Springfield Township Library Renovation: Contractor Inquiry List **Addendum #2**

SUBJECT: MEP Bid Addendum #1 Narrative

SPFLD00611 - LIBRARY BUILDING RENOVATIONS
70 POWELL ROAD, SPRINGFIELD, PA 19064

M300

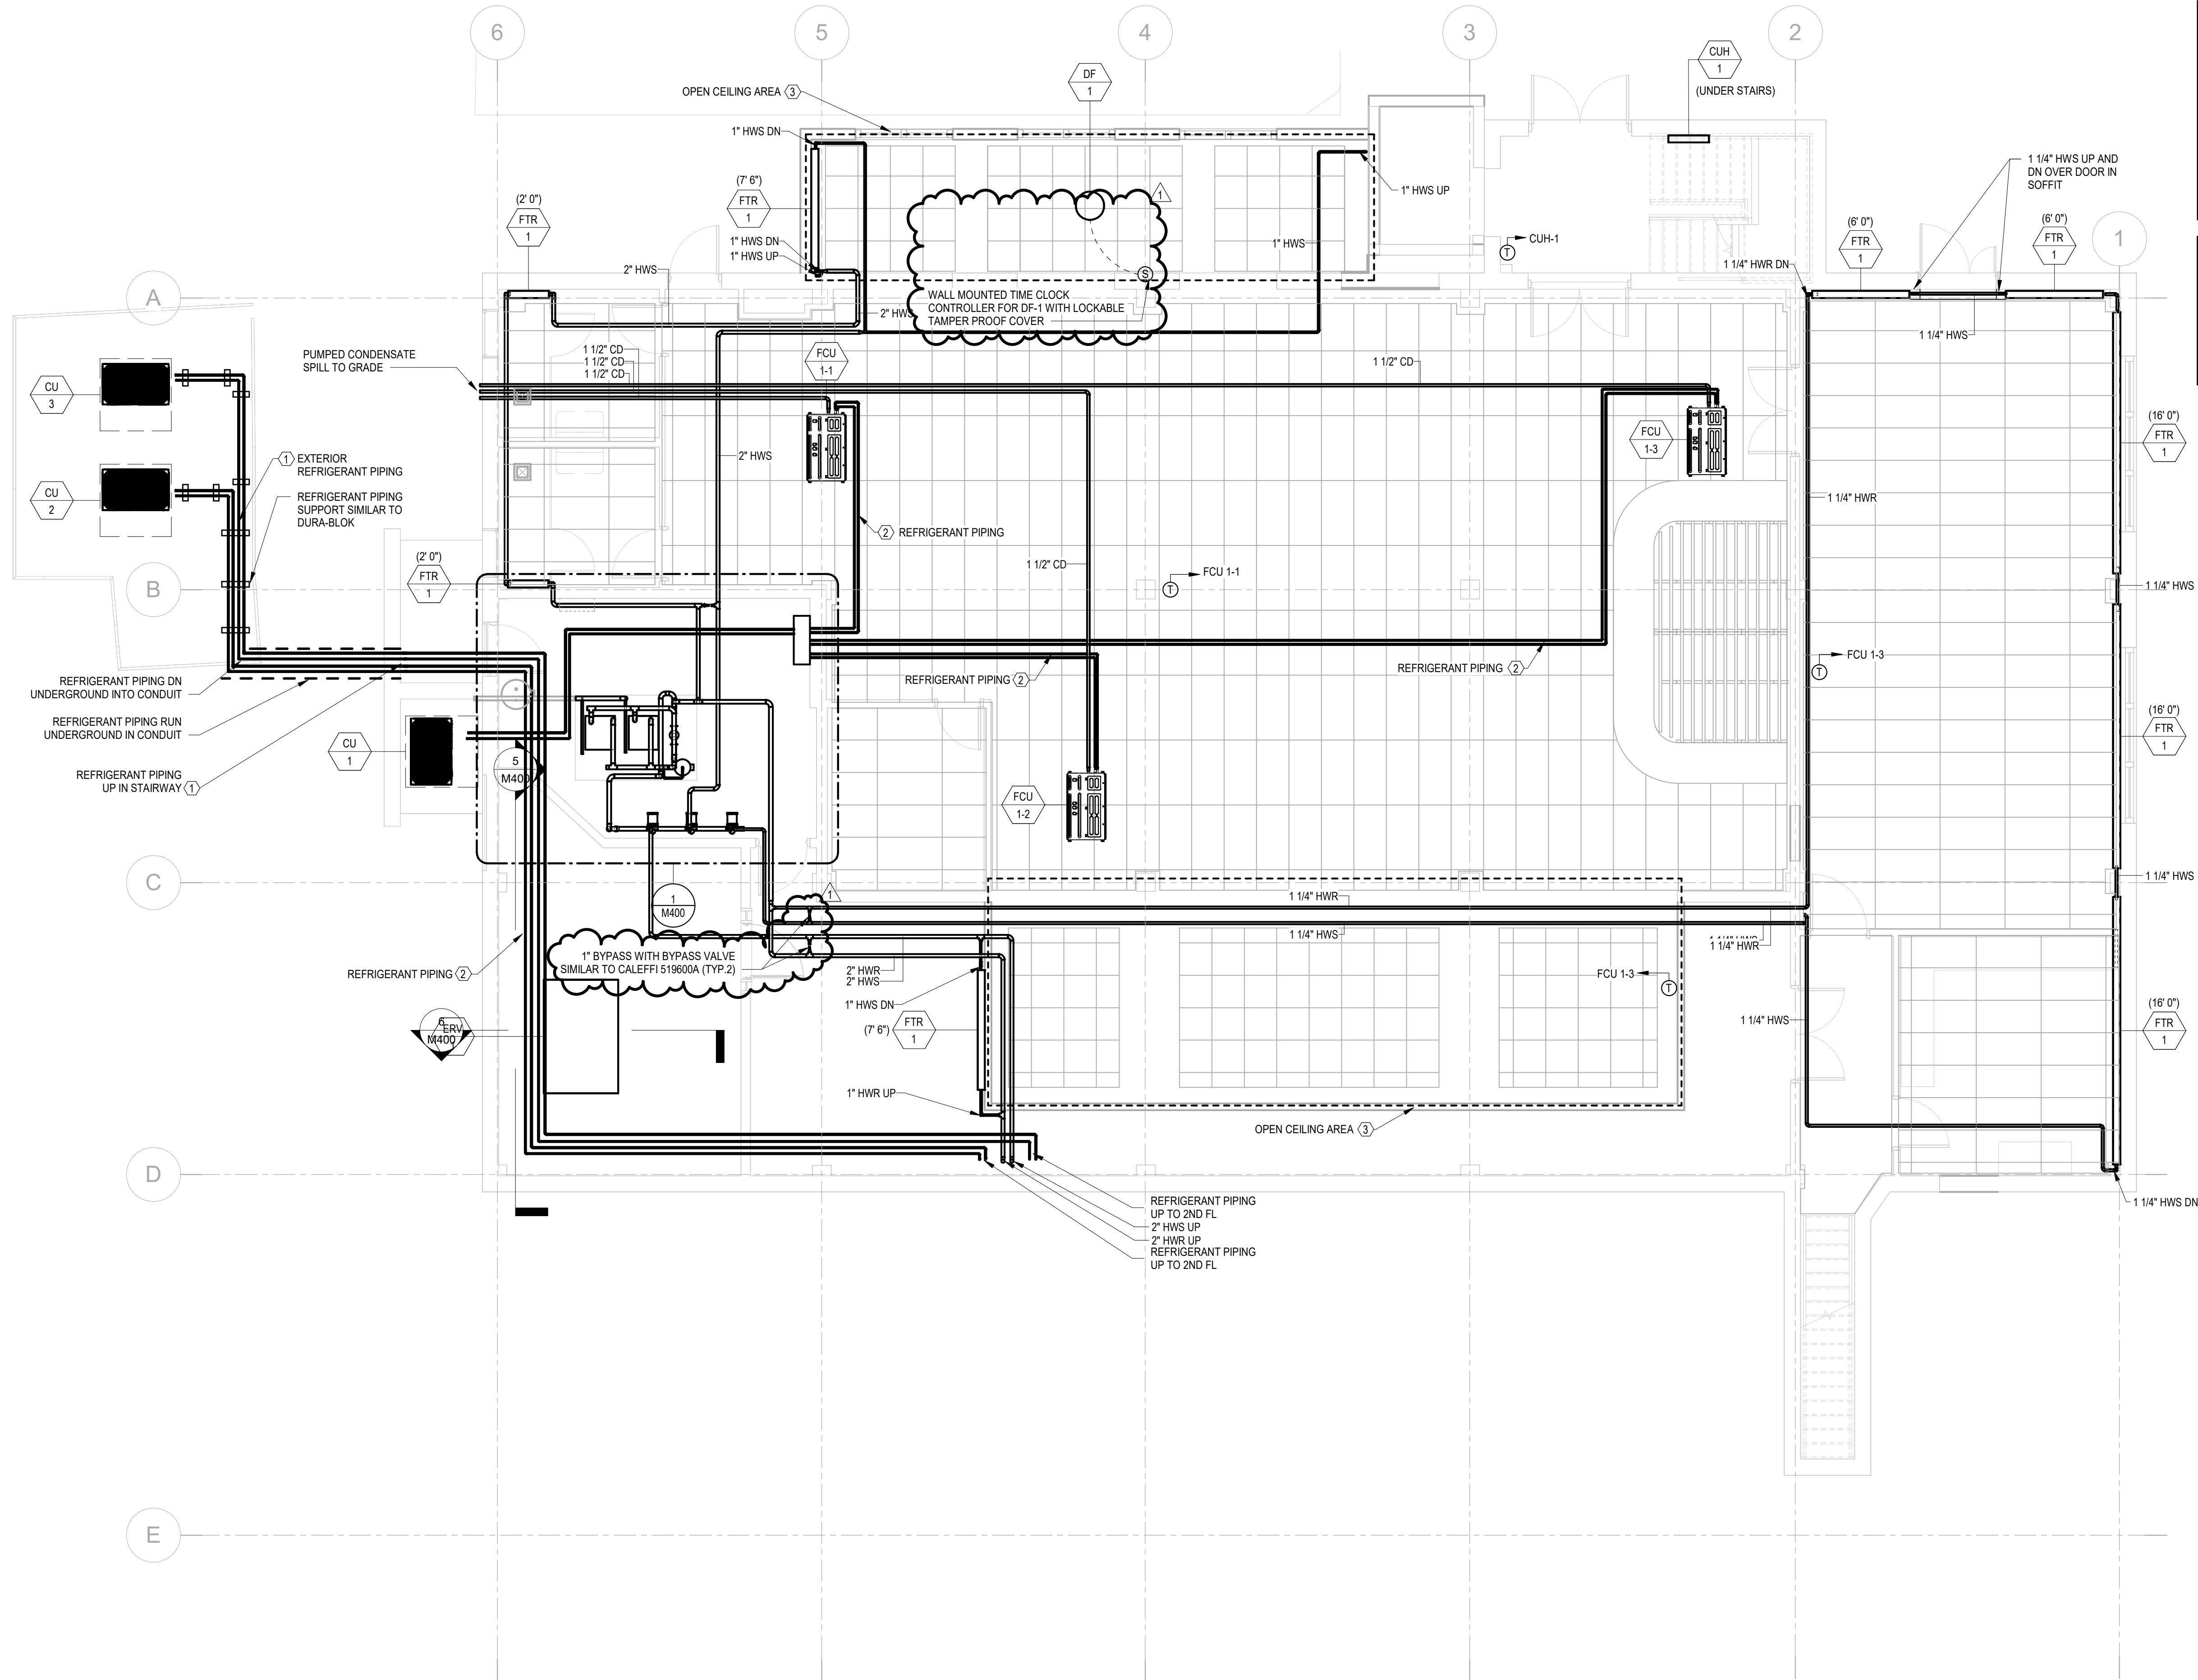
1. Added (2) 1" bypass valves and piping on HWS/R branch lines.
2. Added location for DF-1 time clock controller.

M301

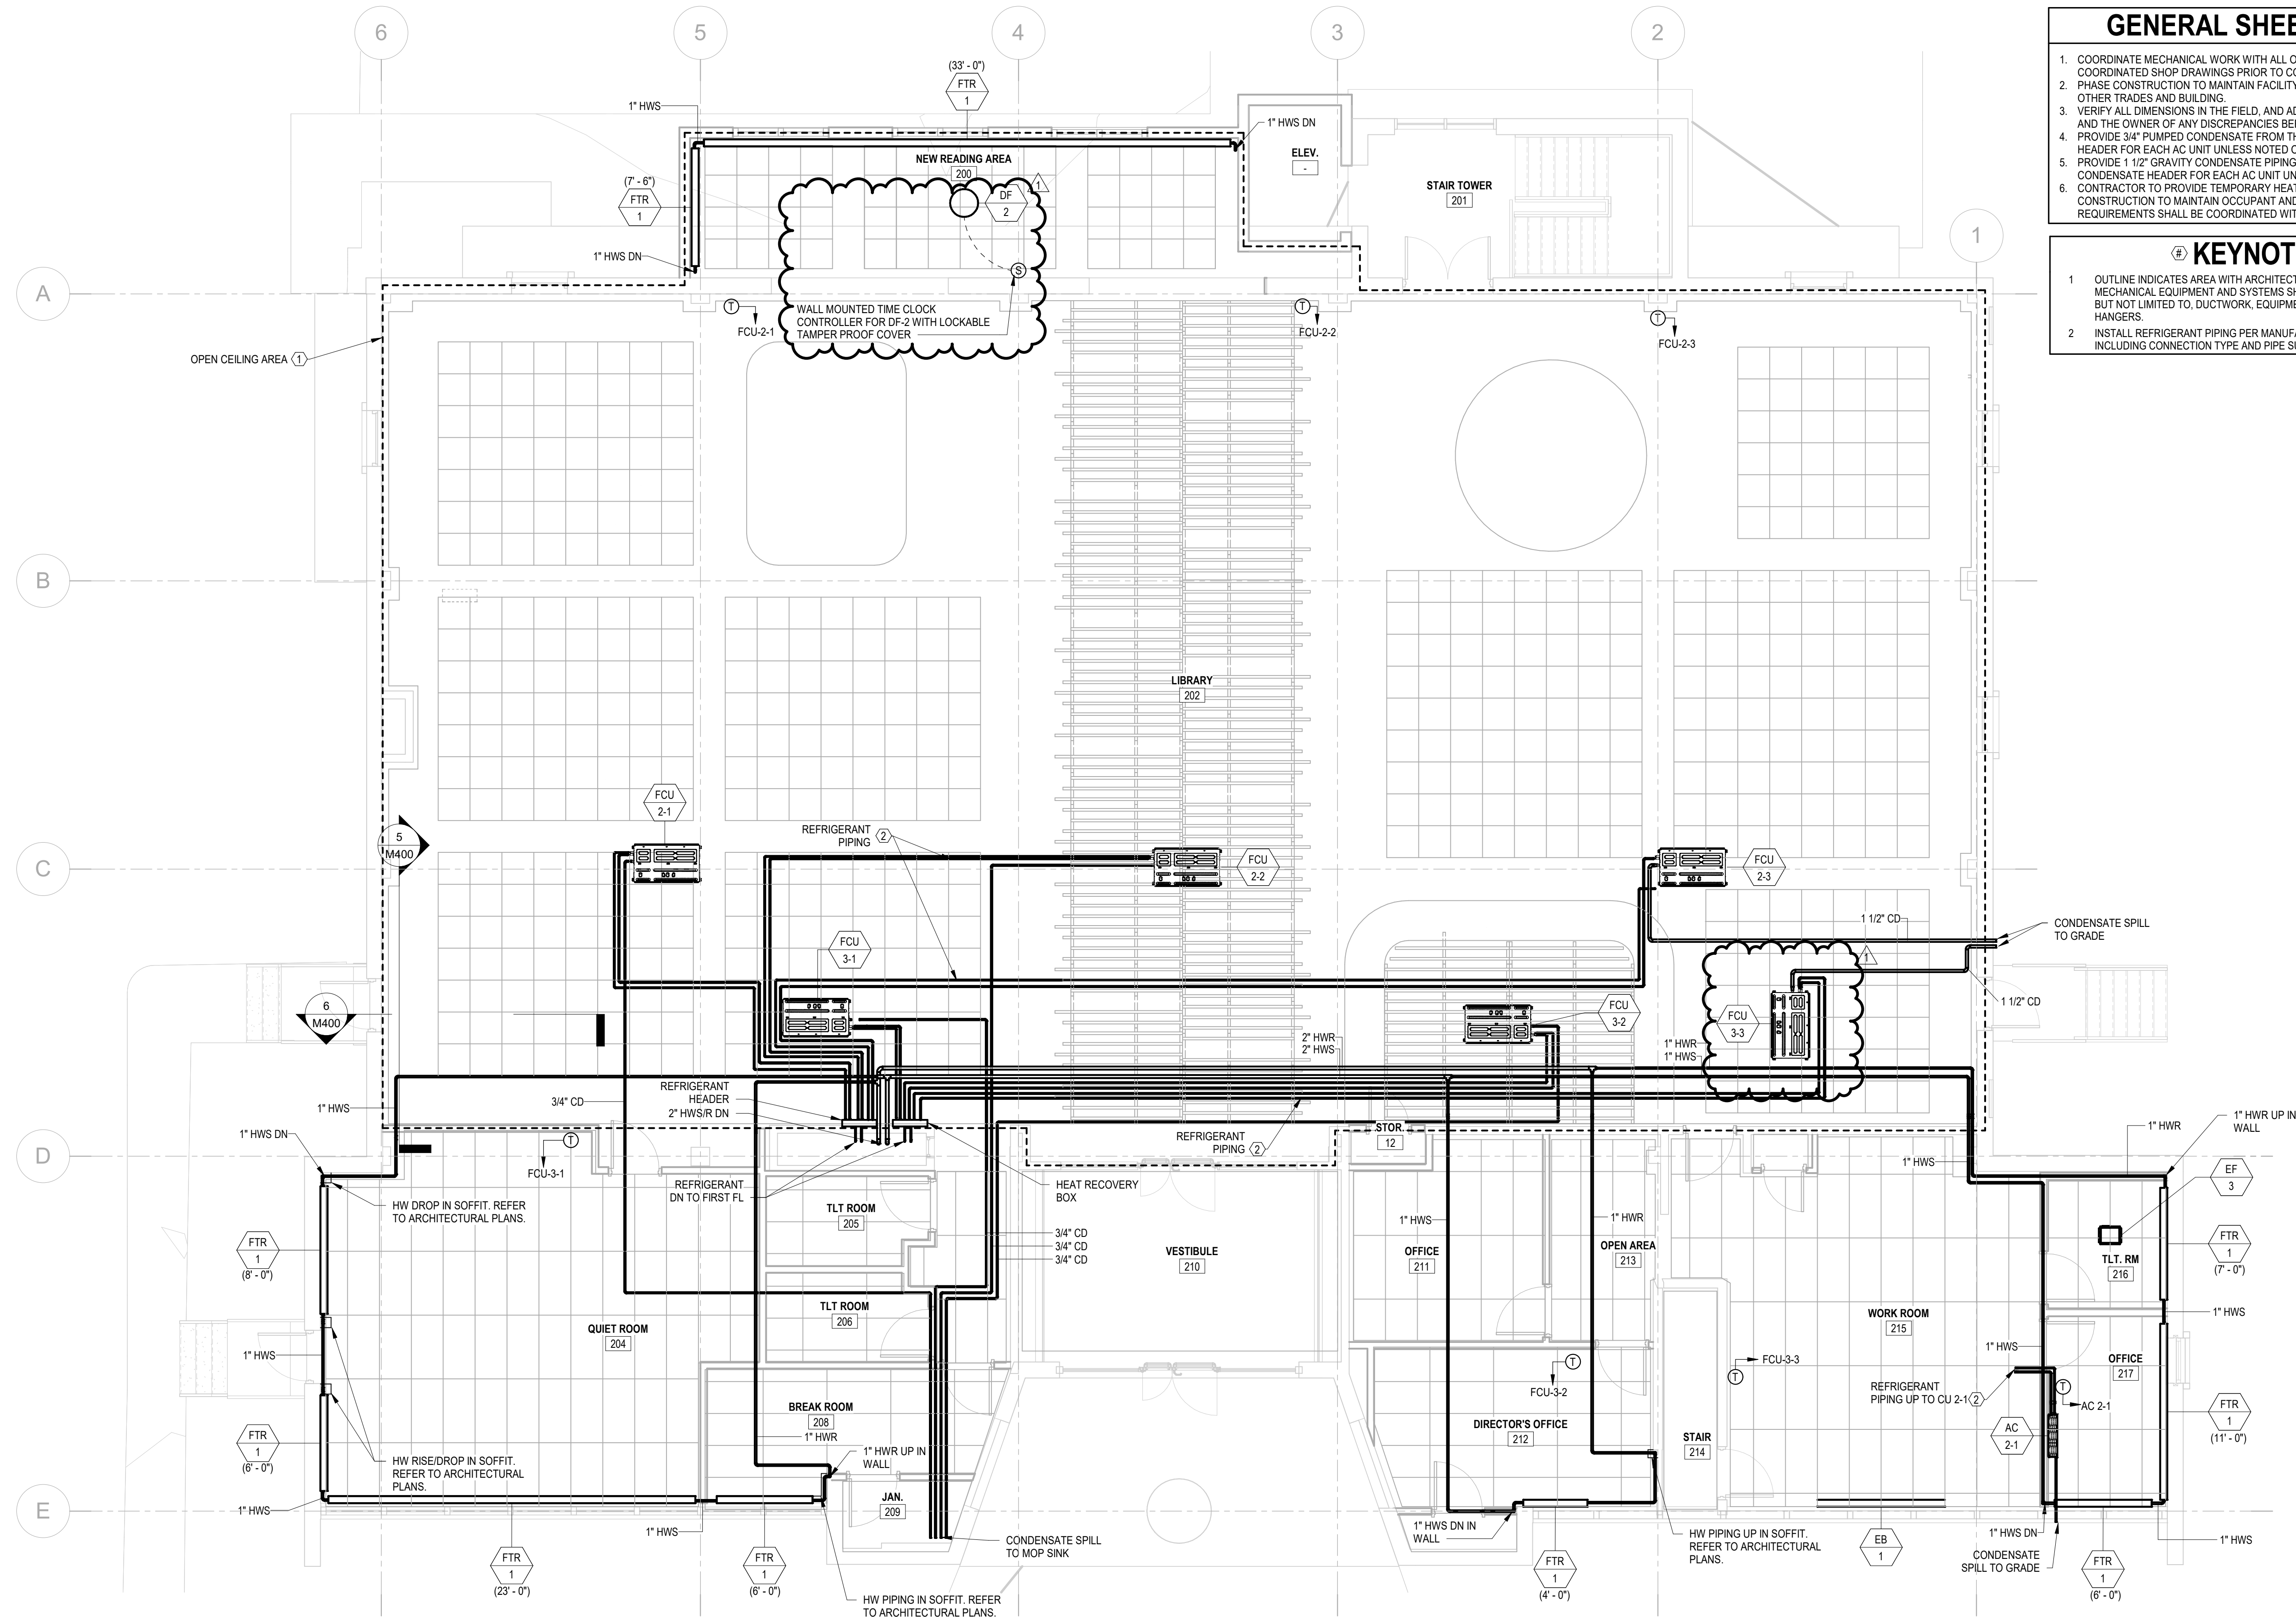
1. Added location for DF-2 time clock controller.
2. Re-oriented FCU 3-3 for constructability in field.
